Part 5 Approval **ACCESS REPORT**

Reference Number: 23307

Client: Stanton Dahl Architects

Site Address: 1 Robyn & 17-19 Pank Parade Blacktown

[Image description: Plan of Ground Level above shows the provision of Accessible parking spaces]

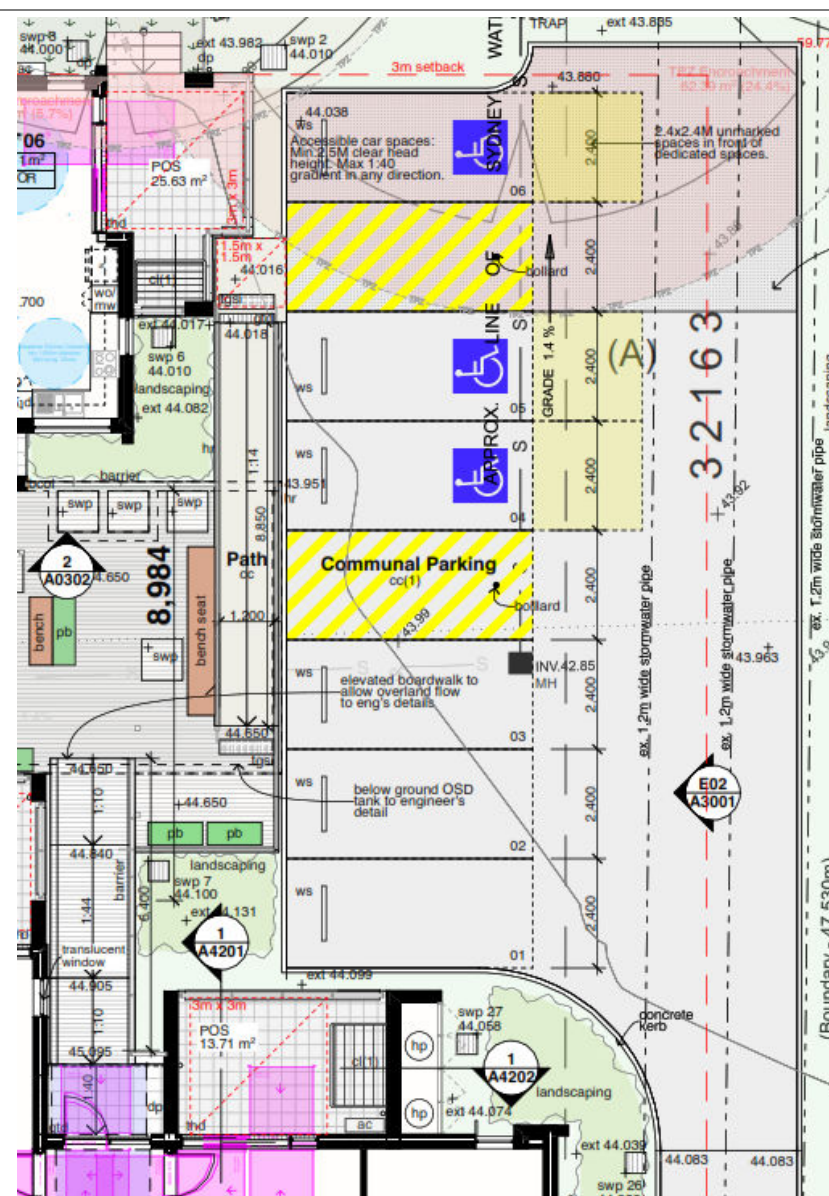
The development is for a social housing provider under Schedule SEPP Housing 2021 - Compliance assessment with Schedule 4 of SEPP.

As such the SEPP sets parking ratios for the development. In this case 1 accessible parking space is required per 5 dwellings. As the development proposes 14 SOUs, 3 x accessible carparking spaces are required for the residential component of the development.

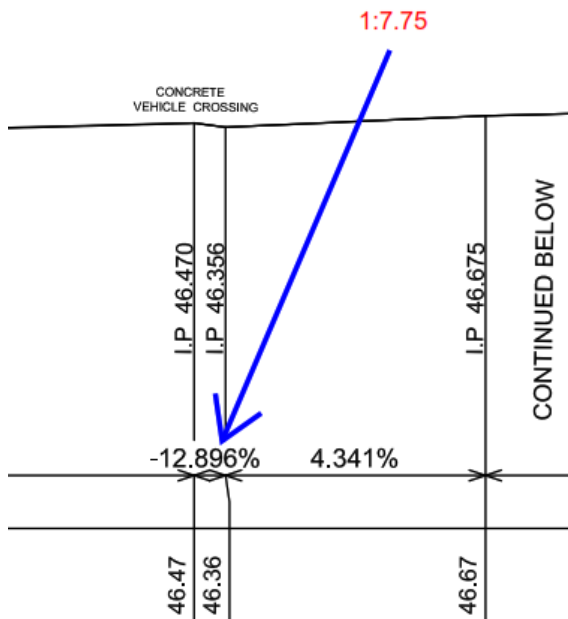
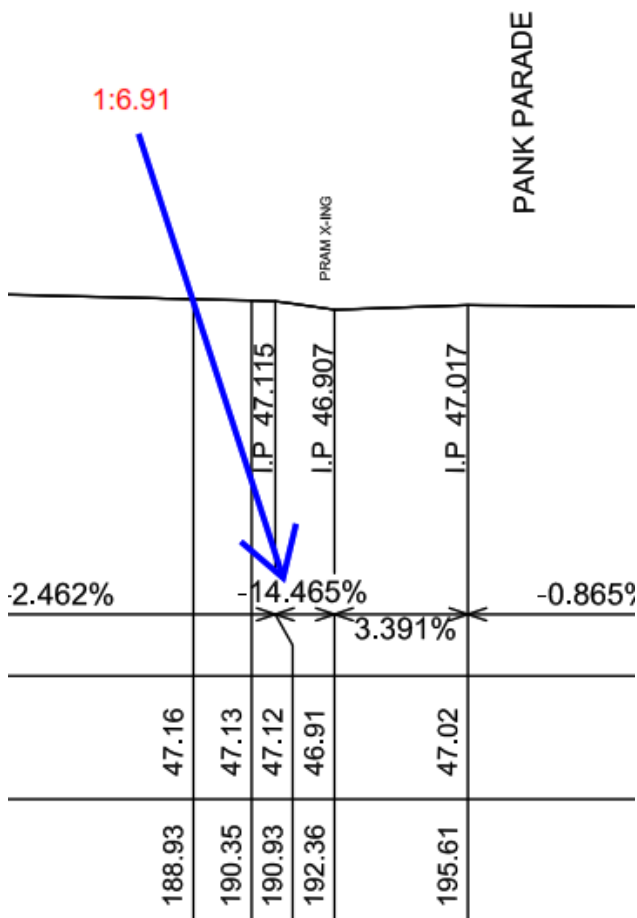
Grades that are out of permissible range are shown below

Max 1:8 permitted on path of travel for maximum 1.5M at a time

Max 1:8 permitted on path of travel for maximum 1.5M at a time

Rectification works required for compliance: Architect is required to redesign the non-compliant section with a maximum 1:8 grade

Rectification works required for compliance: Architect is required to redesign the non-compliant section with a maximum 1:8 grade

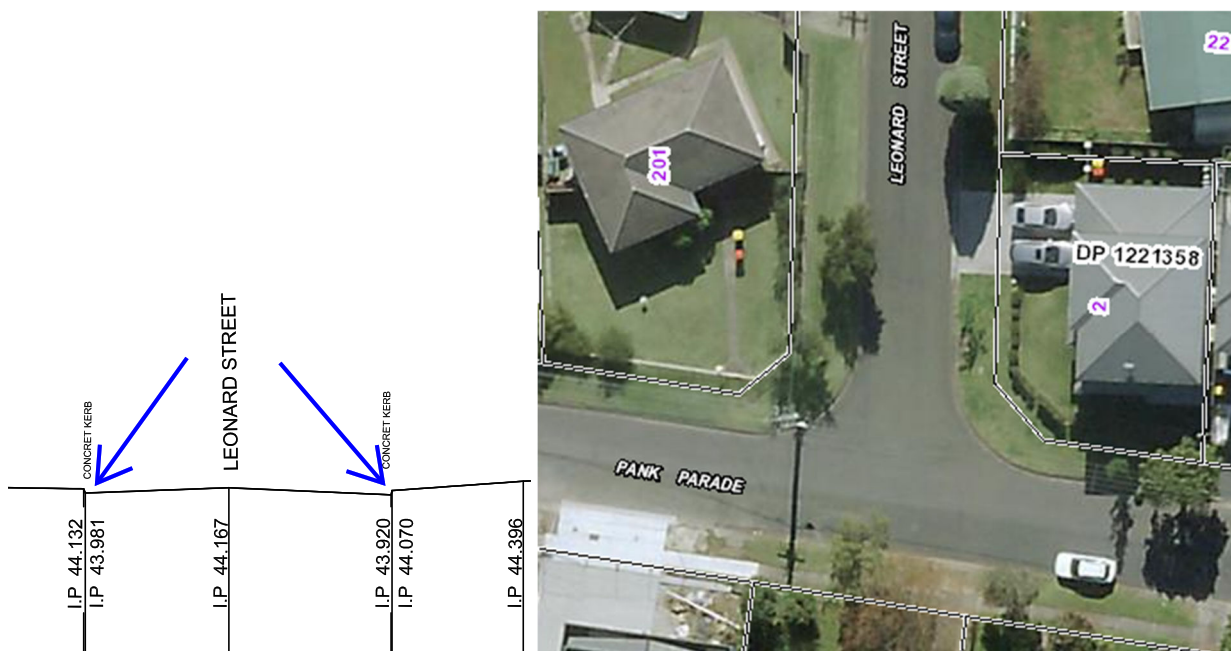
Compliance **Capable of compliance** with upgrades as noted below

3. Survey plan does not provide clear width of the concrete pathway. Min 1M clear is required.

Rectification works required for compliance: Architect is required to detail the clear width of concrete pathway to 1M width.
